**The Town of Clayton
Clayton Board of Adjustment Agenda
Wednesday, September 20, 2017 @ 6:00 PM
Council Chambers**

Application Number: 2017-140-CUP

Project Name: Holy Cross Lutheran Church school expansion, Conditional Use

Re: 2017-110-SP, Holy Cross Lutheran Church, school expansion - Major Site Plan

Signs

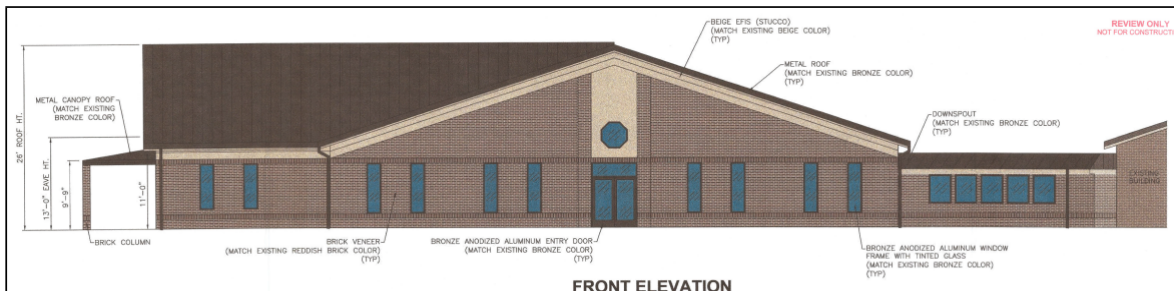
No monument signs are requested at this time. Signage already exists on site for the church. Any new signage will require a sign permit.

PRELIMINARY LANDSCAPE PLAN FOR HOLY CROSS LUTHERAN CHURCH
 CLAYTON TOWNSHIP - JOHNSTON COUNTY, N.C.

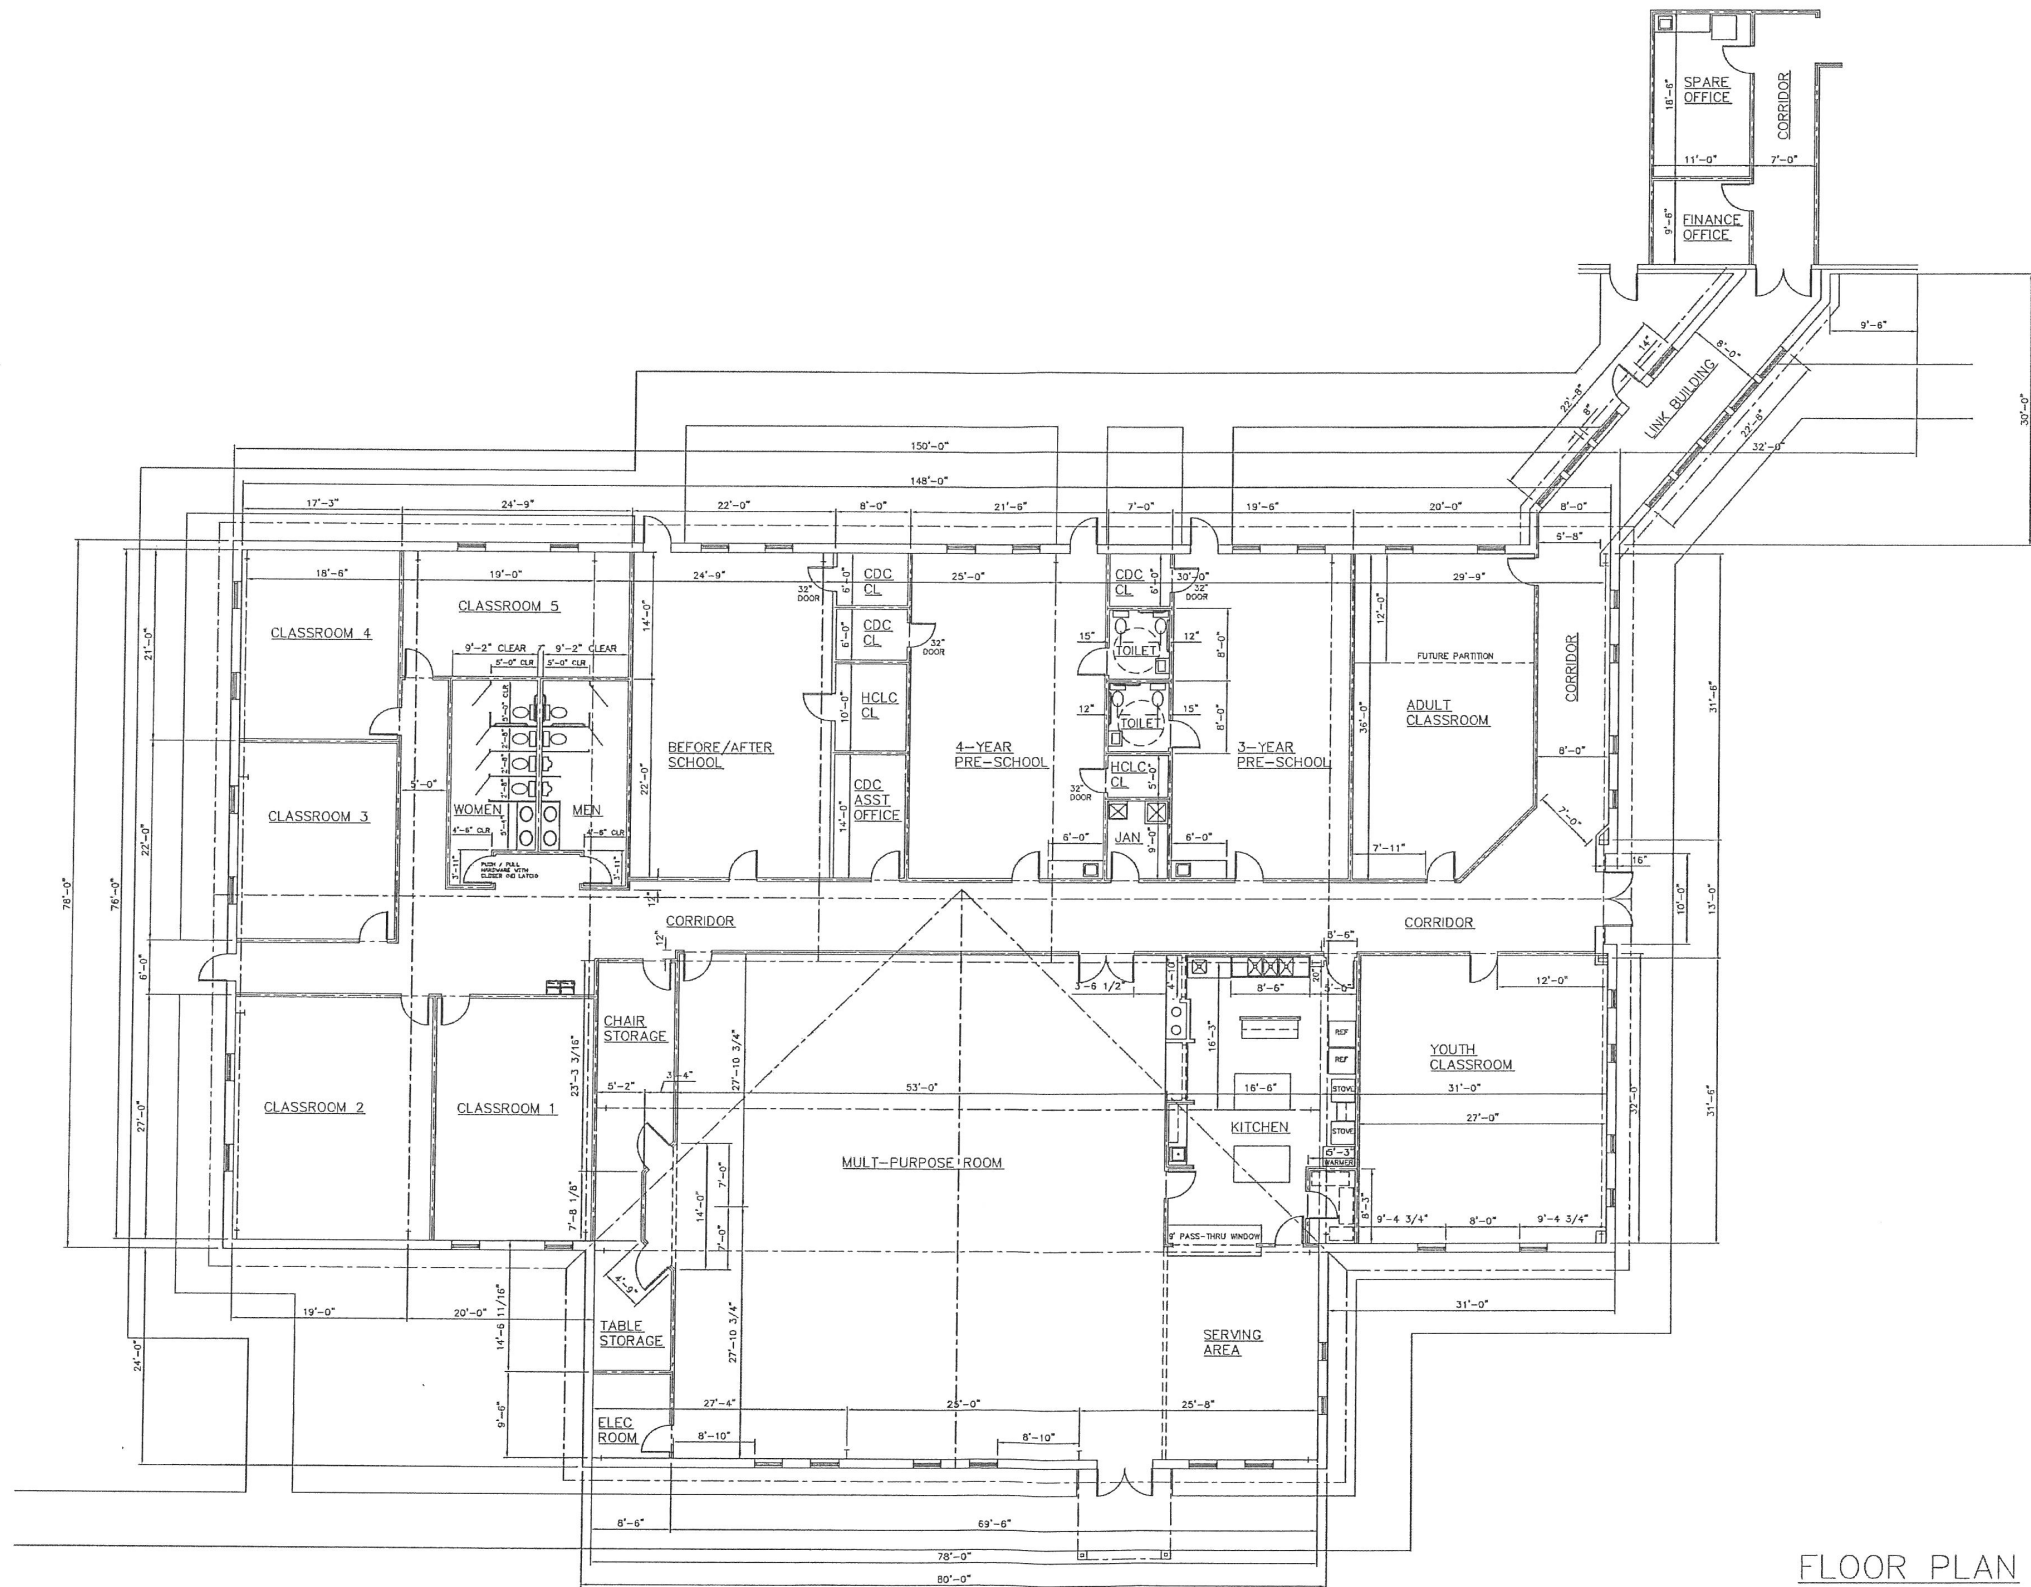
Please find attached the most current site plan that has been submitted to the Planning Dept. for the Holy Cross Lutheran Church school expansion. It does show (on page 10, Landscaping Sheet) that the majority of the woodlands will remain. It is my understanding that the drawing shared at the neighborhood meeting, where the entirety of the woods were shown as converted to "Lawn", was a mistake, and that clearcutting is not intended. Per the plans, tree clearing and grading would be required on the areas planned for the parking lot, school building, and the expanded stormwater pond.
